Selected Insulation Destruction Pressures

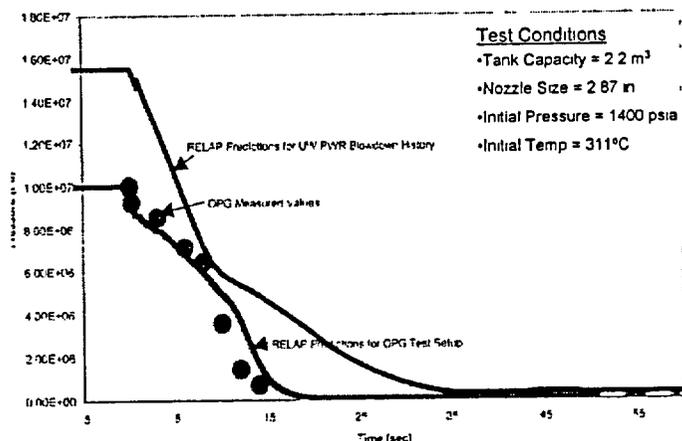
1           The next slide, page 18, shows some more  
2 quantitative information, so that you have an  
3 impression of what the various vulnerabilities are.  
4 Higher damage pressures imply a more robust insulation  
5 application.

6           DR. FORD:   And this is based on just  
7 firing a jet at some things in the laboratory?

8           DR. LETELLIER:   That's correct.  
9 Unprotected fiberglass is perhaps some of the most  
10 vulnerable material, having damage pressures in the  
11 range of 6 to 10 psi.

12          DR. KRESS:   Is old insulation worse than  
13 new insulation?

18          DR. BANERJEE:   So Min-K is fiberglass?  
19 What is Min-K?

23 CHAIRMAN WALLIS: -- planktonic things,  
24 but if they're not bonded together, it's not going to  
25 have this 160 psi resistance.

7 MR. ROSEN: On that previous figure, is  
8 there any thermal lag in these containments?

14          DR. LETELLIER:   I can't comment on that.  
15 There are aging effects that affect the friability of  
16 this material. We have to look at other documents to  
17 answer that.

1 DR. LETELLIER: No. In fact, the robust  
2 nature of the Calcium-Silicate with the aluminum  
3 jacket was actually viewed to be a limitation of the  
4 existing BWR data. That's one of the reasons that we  
5 requested a test program, in cooperation with Ontario  
6 Power Generation, on the next figure.

## Example Section of Debris Transport Chart

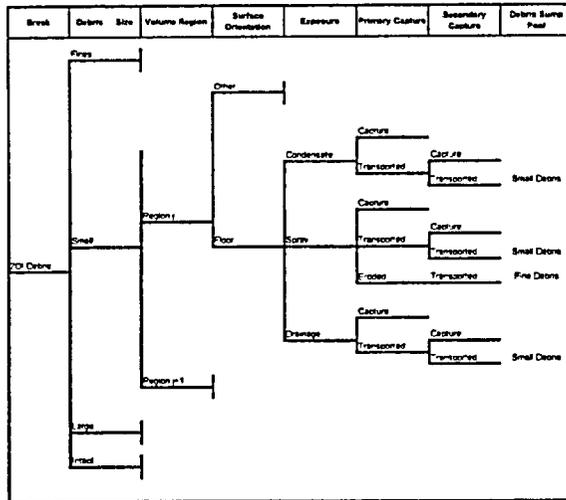
18 DR. BANERJEE: Do you think this level of  
19 detail is appropriate? I mean, it's like having too  
20 many significant figures in a number.

7 DR. BANERJEE: But do you need this level  
8 of detail to do that?

9 DR. LETELLIER: The answer is no.

14 DR. LETELLIER: This is illustrative and  
15 it's also educational, if you will. It lets the  
16 plants prioritize where to put their analysis effort.

9 DR. LETELLIER: It basically walks you  
10 through the disposition of a debris fragment depending  
11 on its size, whether it's initially deposited on the  
12 floor, on a vertical surface, on a horizontal surface;  
13 whether it's impacted by sprays, direct impingement,  
14 or condensation; whether it is subject to secondary  
15 motion through pools on elevations, different  
16 elevations of the plant, and, eventually, whether it's  
17 deposited into the pool.

## Steady-State Velocity Maps (Lower)

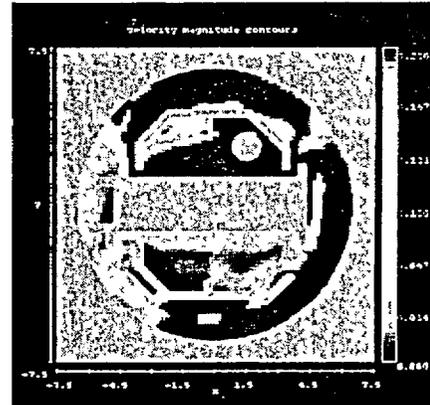
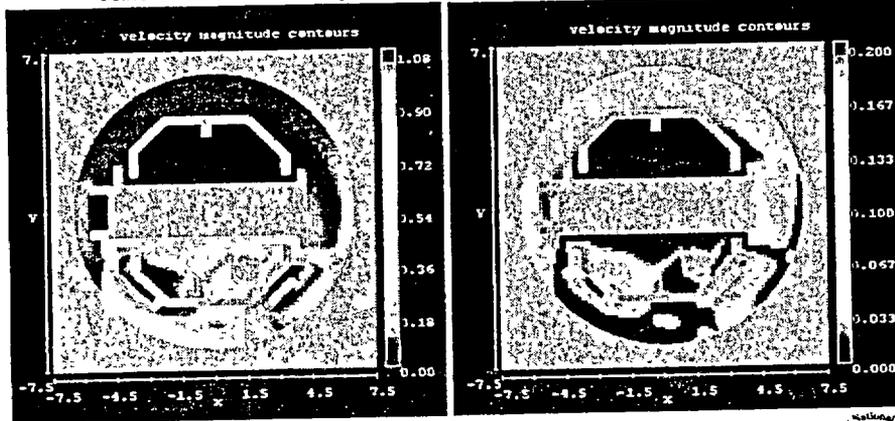
6 DR. BANERJEE: Is this a plan view?

7 DR. LETELLIER: It is. It is a plan view  
8 at the floor level of a representative of --

5 DR. LETELLIER: The figure on the right  
6 has been scaled to a maximum velocity of .2 feet per  
7 second. From the individual effects test, that's sort  
8 of a rule-of-thumb threshold for debris movement. If  
9 it exceeds .2, it's very likely to be mobile. If it's  
10 less than .2, there's an opportunity for settling.

## Transport Required for Failure

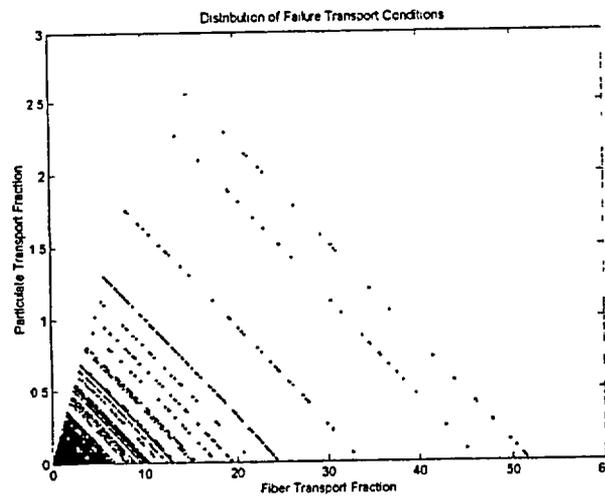
18 CHAIRMAN WALLIS: This is for an existing  
19 screen and a real reactor, a real containment, this  
20 figure?

5 If you combine this failure threshold with  
6 all of the debris sources, you can generate the last  
7 figure, which shows you the range of pool -- well, of  
8 total transport that would be required to induce  
9 failure of the screen.

18 DR. LETELLIER: Again, these dots on this  
19 Figure 44 do not represent particulates. They  
20 represent scenarios.

15 DR. LETELLIER: This is a representation  
16 of a screen. Depending on the area and the approach  
17 velocity, there are plant configurations that could be  
18 blocked with one cubic foot of fiber and some amount  
19 of particulate. That's not a generic statement.  
20 That's very plant-specific.

22 DR. LETELLIER: Now your comment about the  
23 threshold, at the far left there is a missing line  
24 that essentially extends vertically upward.

12 DR. LETELLIER: That is correct, but the  
13 point of this slide is to demonstrate that the  
14 licensees need to assess their own vulnerabilities in  
15 much the same way. They need to have an understanding  
16 of transport and head loss in order to respond to the  
17 Generic Letter.
